WOLF CREEK
NUCLEAR OPERATING CORPORATION

ET 07-0052

Subject: Docket No. 50-482: Response to Request for Additional Information Relating to Replacement of the Main Steam and Feedwater Isolation Valves and Controls

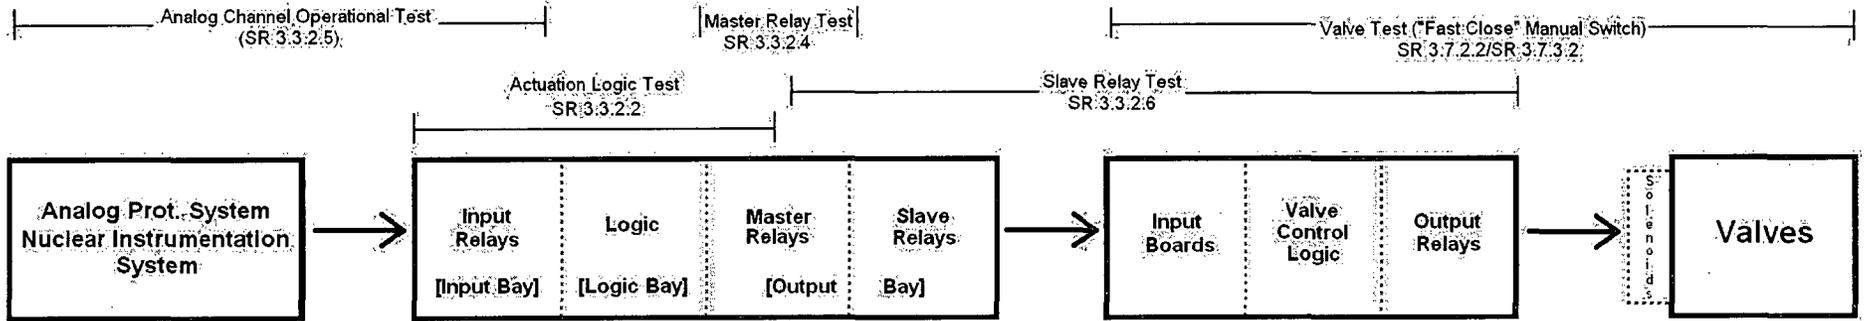
2. *It appears, since the existing TS 3.7.3, "Main Feedwater Isolation Valves (MFIVs)," has the applicable Mode 3, that the corresponding ESFAS function for main feedwater line isolation (i.e., closing the MFIVs) in TS Table 3.3.2-1 should also be required to be operable in Mode 3. Is this why Mode 3 is proposed to be added to the revised Function 5.a (SSPS) and the new Function 5.b (MSFIS)? Is the proposed replacement of Condition H with Condition G the result of adding Mode 3 to these two functions? In other words, discuss if the proposed Condition G results from the need to have a required condition in TS Table 3.3.2-1 for the revised Function 5.a and new Function 5.b such that, if the functions are inoperable, the plant would be required to eventually enter a mode where the functions are not required to be operable. The proposed Condition G requires the plant to eventually enter Mode 4 and the existing Condition H only requires that the plant eventually enter Mode 3, whereas the revised Function 5.a and new Function 5.b are proposed to be operable in Mode 3.*

Response: As discussed in Attachment I to ET 07-0004 (page 7), Function 5.a is revised to include MODE 3 (including footnote (j)) and the applicable Condition is revised to Condition G to address the expanded Applicability in TS 3.7.3. Currently, Function 5.a requires 2 trains of Automatic Actuation Logic and Actuation Relays be OPERABLE in MODES 1 and 2 (including footnote (j) for MODE 2). It was determined that since current TS 3.7.3 required the MFIVs to be OPERABLE in MODE 3, the Applicable MODES of the instrumentation that provides an actuation signal should also be OPERABLE in MODE 3.

TS Section 1.3, Completion Time, states in part: "An ACTIONS Condition remain in effect and the Required Actions apply until the Condition no longer exists or the unit is not within the Limiting Conditions for Operation (LCO) Applicability." Conditions/Required Actions are written to either restore compliance with the LCO or to direct exiting the Applicability of the Specification. With the proposed addition of MODE 3 to Function 5.a, Required Action H.2 (Condition H) would not provide for exiting the Applicability of TS 3.3.2. Therefore, the

proposed use of Condition G provides the same actions but allows the option of exiting the Applicability. Condition G is applied to new Function 5.b to either restore compliance with the LCO or to direct exiting the Applicability.

Figure 1

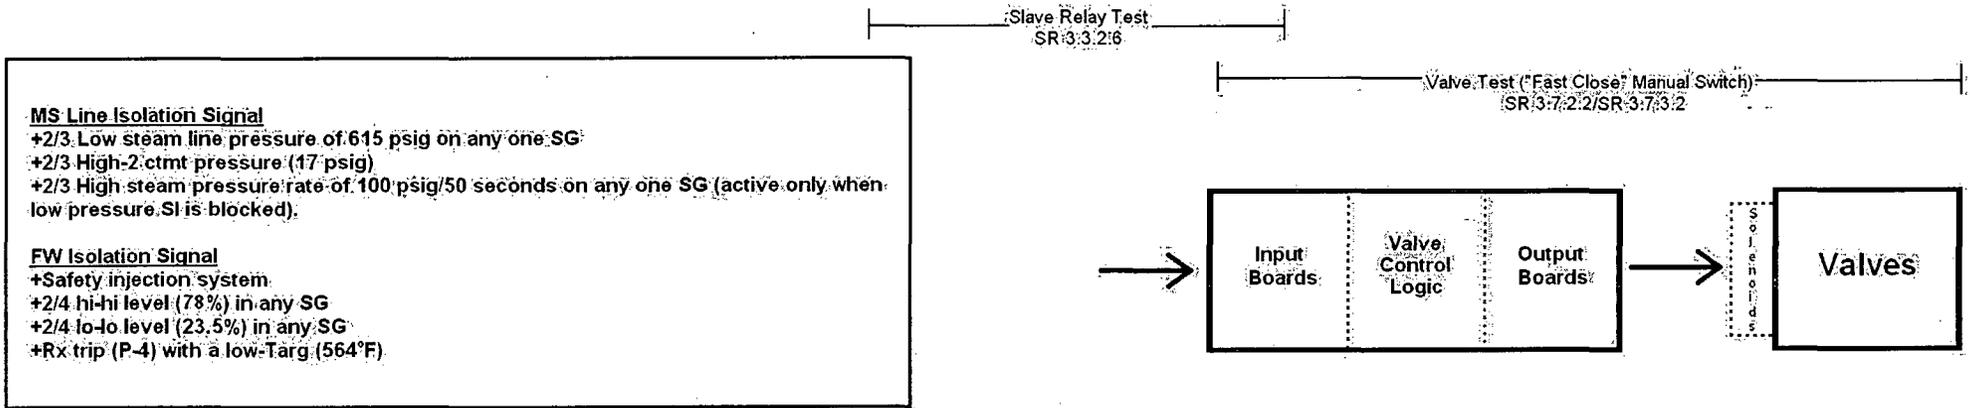
3. *In the current TS Table 3.3.2-1, the exponent for the applicable Modes 2 and 3 for the proposed revised Function 5.a (SSPS) is the revised footnote j, and the exponent for the proposed Modes 2 and 3 for the new Function 5.b (MSFIS) is the new footnote k. It appears that the revised footnote j and new footnote k are to account for the proposed changes to TS 3.7.3, "Main Feedwater Isolation Valves (MFIVs)," to include the main feedwater regulating valves (MFRVs) and MFRV bypass valves in TS 3.7.3. Address if this is correct and if the existing footnote j would be the exponent for Mode 3, as it currently is for Mode 2 in TS Table 3.3.2-1, for the revised Function 5.a and new Function 5.b if the proposed changes to LCO 3.7.3 are not made.*

Response: As discussed in the response to item 2 above, Function 5.a is revised to include MODE 3 (including footnote (j)). For Function 5.a, footnote (j) is applied to MODE 2 and the proposed addition of MODE 3. Current footnote (j) provides as exception to the Applicable MODES or Other Specified Conditions that allows the Turbine Trip and Feedwater Isolation Function 5.a (Automatic Actuation Logic and Actuation Relays) that allows the actuation logic and actuation relays to be inoperable in MODE 2 when all MFIVs are closed. Current Footnote (j) is revised to address the proposed addition of the Main Feedwater Regulating Valves (MFRVs) and MFRV bypass valves to TS 3.7.3, "Main Feedwater Isolation Valves (MFIVs)." Further review has determined that an additional change is necessary to the proposed footnote (j). This additional change is necessary to ensure the exception accurately prescribes when Function 5.a is required to be OPERABLE. Function 5.a is required to be OPERABLE in MODES 1, 2, and 3 to isolate feedwater flow to the steam generators. The revised footnote (j) specifies that in MODES 2 and 3, the actuation logic and actuation relays are required to be OPERABLE except when all MFIVs are closed and de-activated; and all MFRVs are closed and de-activated or closed and isolated by a closed manual valve; and all MFRV bypass valves are closed and de-activated, or closed and isolated by a closed manual valve, or isolated by two closed manual valves. The actuation circuitry must be OPERABLE in the event any of these sets of valves should require an automatic closure signal. This is consistent with NUREG-1431, Rev. 3.1, "Standard Technical Specifications Westinghouse Plants."

New footnote (k) which is applied to MODE 2 and MODE 3 for new Function 5.b (Turbine Trip and Feedwater Isolation – Automatic Action Logic (MSFIS)) specifies that the actuation logic is required to be OPERABLE in MODE 2 and MODE 3 except when all MFIVs are closed and de-activated. Footnote (j) is not applicable to new Function 5.b as the MSFIS does not provide any control functions for the MFRVs or MFRV bypass valves. If the proposed changes to TS 3.7.3 were not made (i.e., the addition of the MFRVs, MFRV bypass valves, and the deactivation of a closed MFIV) and new Function 5.b were being added to TS Table 3.3.2-1, the existing footnote (j) would be appropriate for Function 5.b.
